CONSUMERS POWER COMPANY

PALISADES PLANT

AMENDMENT TO PROVISIONAL OPERATING LICENSE

Amendment No. 112
License No. DPR-20

FIGURE 4.14.1 - SUPPLEMENTARY SAMPLING FLOW CHART

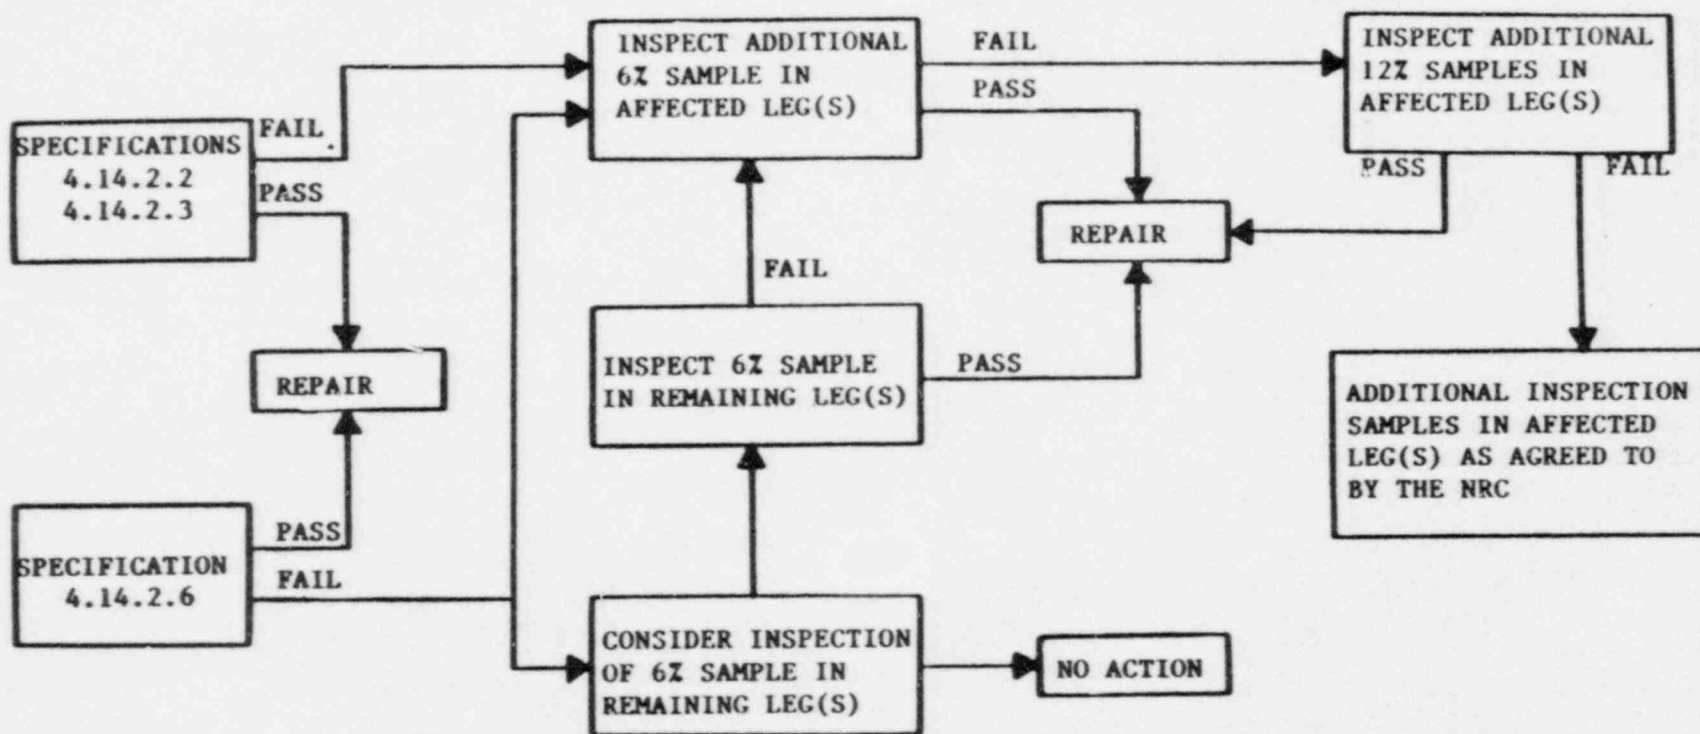
- 4.14.3 Supplementary Sampling Requirements /
- 4.14.3.1 If the inspection pursuant to 4.14.2.2 and 4.14.2.3 or 4.14.2.6 yields results that exceed one or more of the following criteria, then additional samples of unplugged tubes shall be inspected according to Figure 4.14.1. /

4.14.3.4 When applying the criteria of Specification 4.14.3.1 to the tube sample inspection results, the samples are not to be treated cumulatively. The criteria shall be applied only to the inspection results from the immediate additional sample when deciding whether or not to inspect the next additional sample in the progression of Figure 4.14.1.

The supplementary sampling requirements in Specification 4.14.3 are intended to provide guidance in determining the appropriate action in the event that any of the criteria of Specification 4.14.3.1 are exceeded. These requirements will serve to help clarify the nature and extent of additional or new degradation in the steam generators. The results of inspection samples are not treated cumulatively because as the nature and extent of the additional or new degradation becomes clearer with the inspection of more tubes, the criteria for selecting tubes for additional samples may change. Therefore, it is not appropriate to combine the results of two separate inspection samples when the tube selection criteria differ between them.
